ALEXA LF Software Update Package 4.3

for ALEXA LF cameras (SUP_AlexaLF_4.3_44087)

RELEASE NOTES

This document describes changes to ALEXA LF cameras that are part of ALEXA LF SUP 4.3 in contrast to ALEXA LF SUP 4.2.

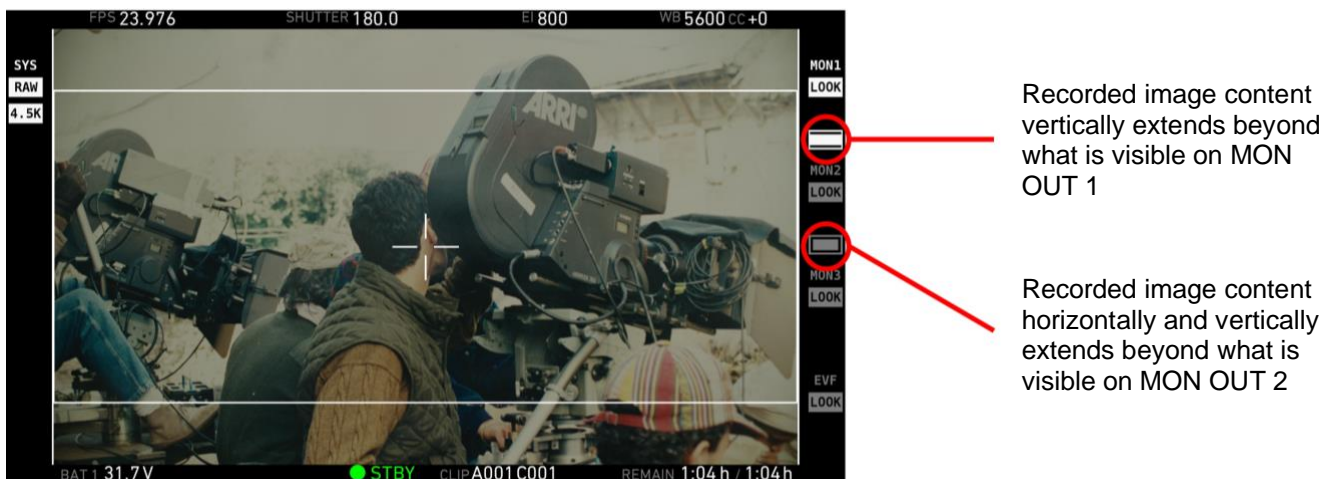
With Software Update Packages prior to ALEXA LF SUP 4.3, an orange line will be shown at the frame boundaries of the monitoring image, if less than the recorded area is shown on the EVF or on the MON OUT image, when the MAGNIFICATION feature is used as shown in the graphic below.

This is a useful and popular feature, but the orange line could get distracting when shooting on low light levels and would also appear unintentionally inside the frame when LDS info was set to ON (see below).

From ALEXA LF SUP 4.3 on, if less than the recorded area is shown on the EVF or on the MON OUT image, the orange line will not be shown any longer. Instead, new warning icons will be shown in the status area to the right of the image. See the table and image below for details.

Indicates that the recorded image content horizontally (left and right) extends beyond what is visible on the output.
	Indicates that the recorded image content vertically (above and below) extends beyond what is visible on the output.
	Indicates that the recorded image content horizontally and vertically extends beyond what is visible on the output.
